Proposed Front Elevation (North Facing)

Revision	Description	Date
Rev. A	Rooflight to front elevation moved over further to the case officers comments.	05/11/21
Client	Mr & Mrs Bould	
Project	11 Sprink View Cottage Biddulph Moor Extension & Alterations	
Drawing Title	Proposed Elevations	
Drawing Ref.	P263 - 203	Rev. A
Date	12/09/21	Scale 1:50
Status	Feasibility	Bldg. Regs
Status	Planning	Tender
Status	Construction	Construction

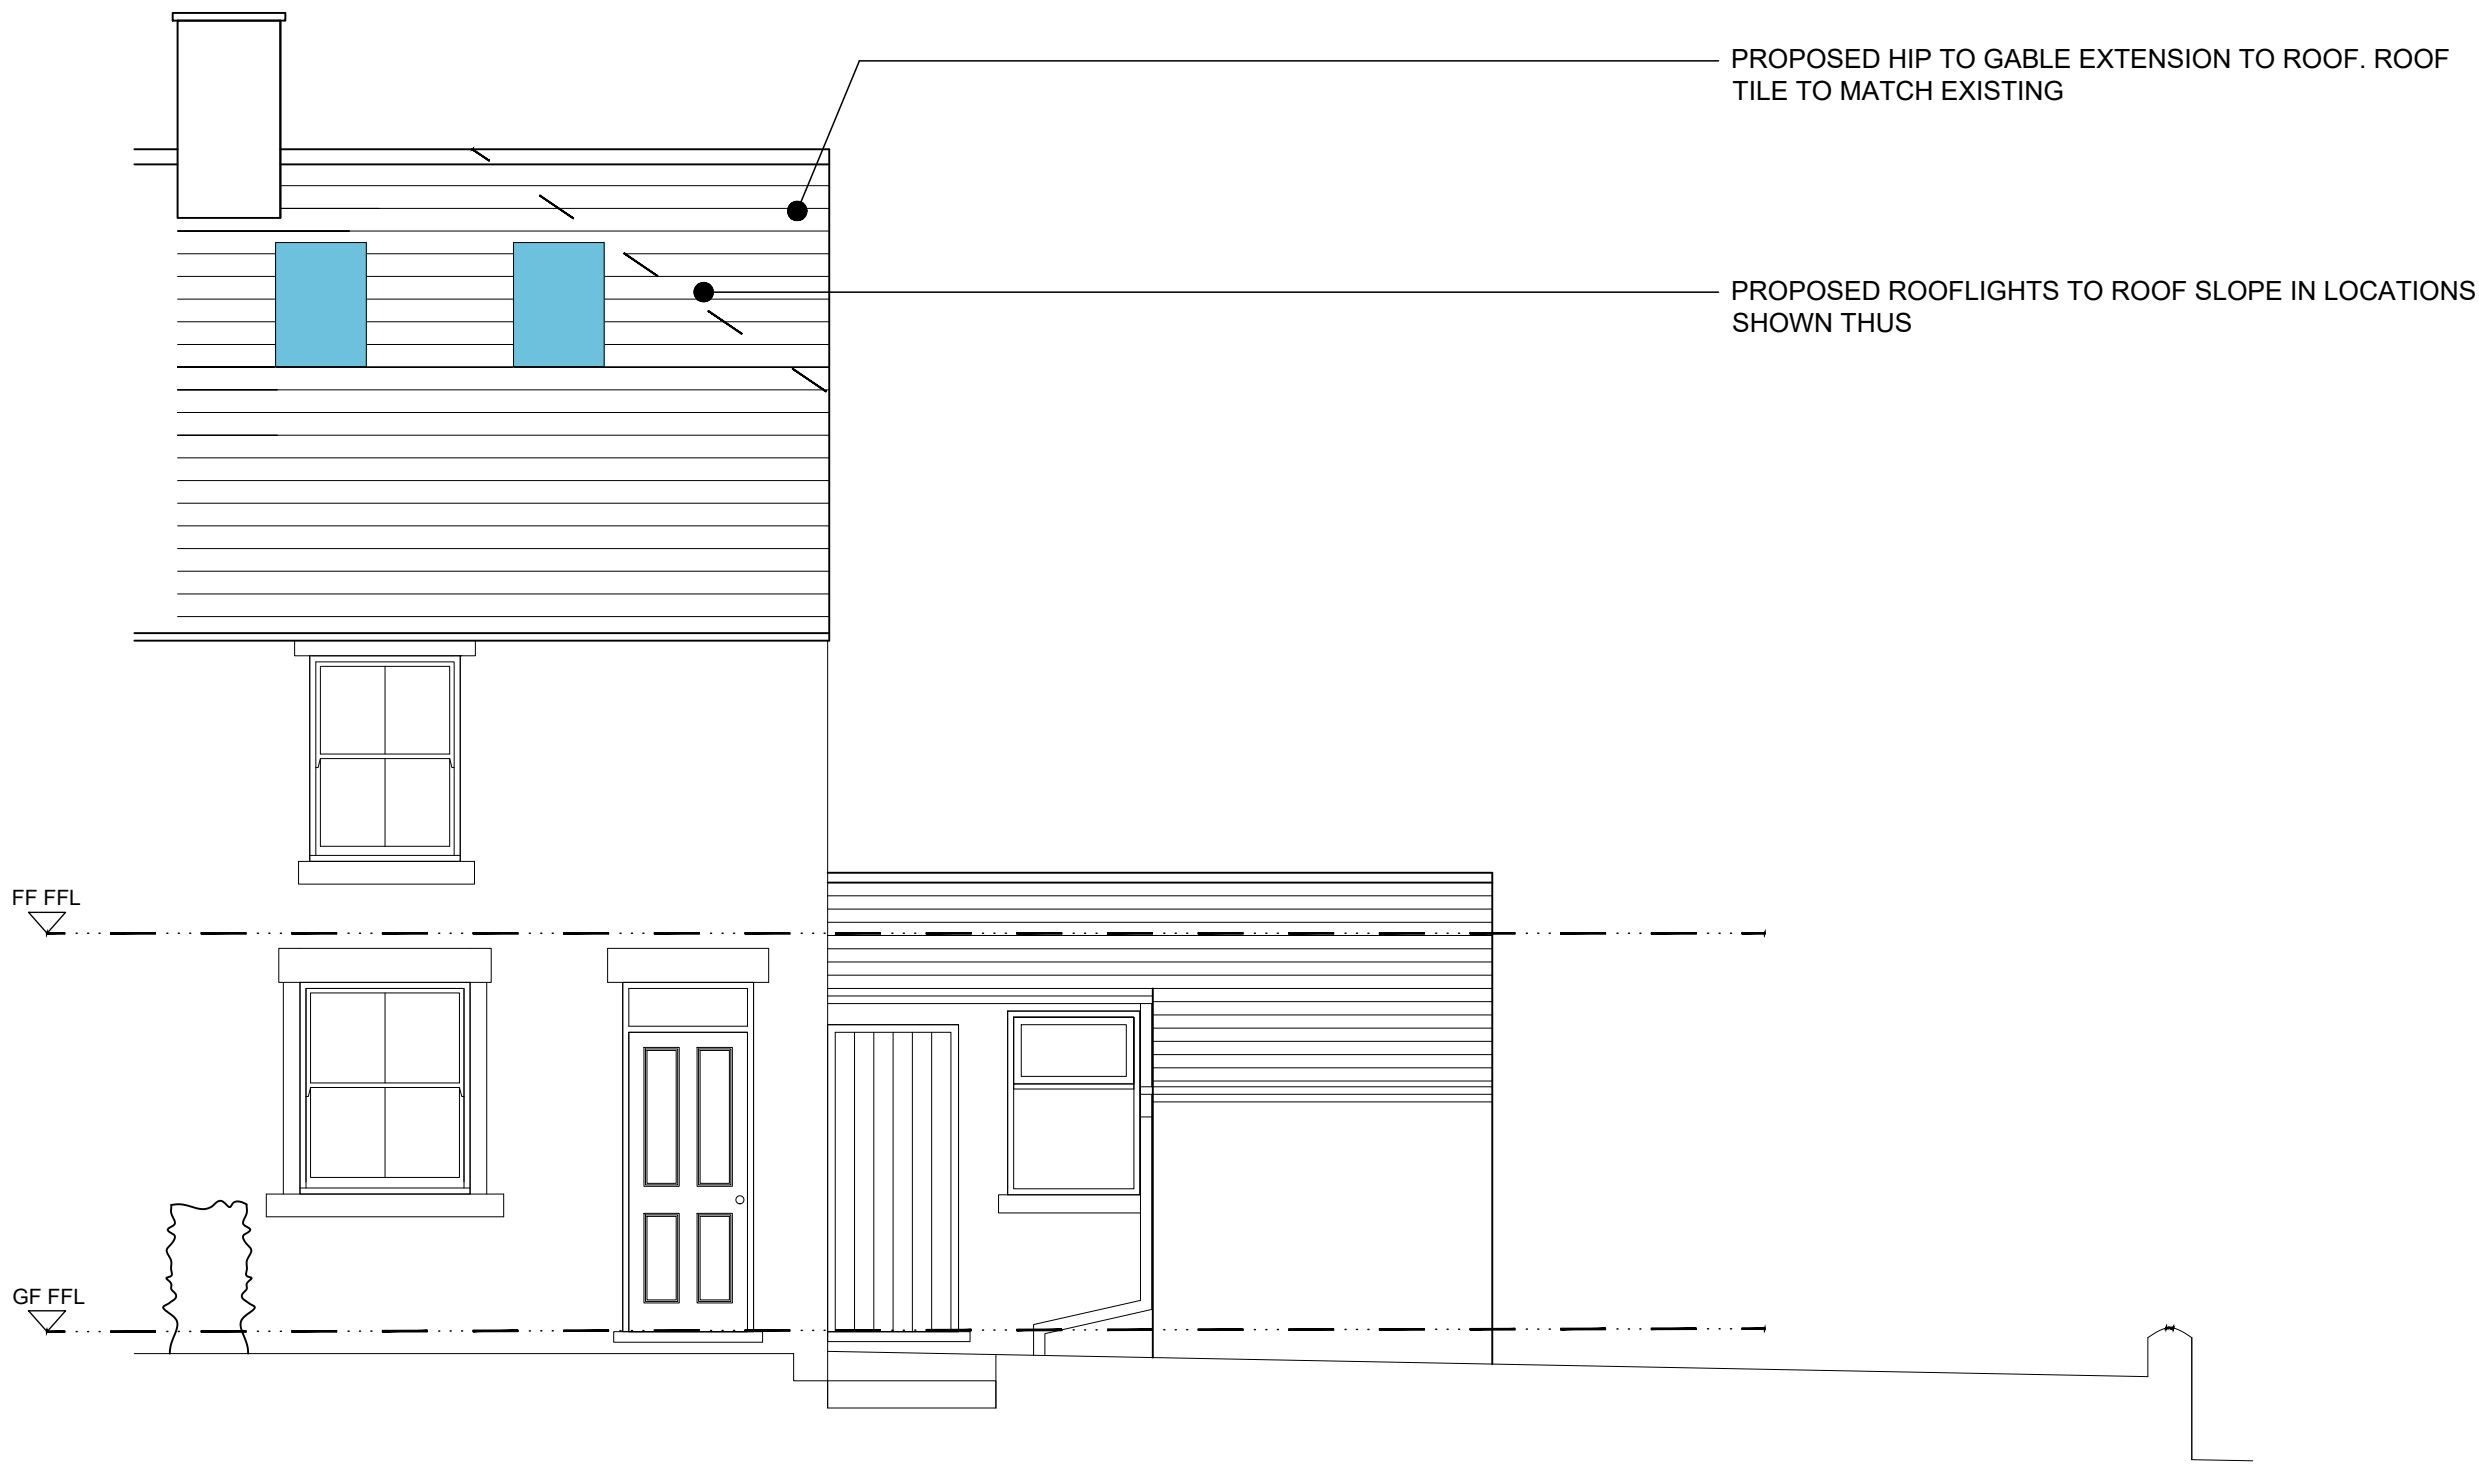
Rev. A. Rooflight to front elevation moved over further to the case officers comments. 05/11/21
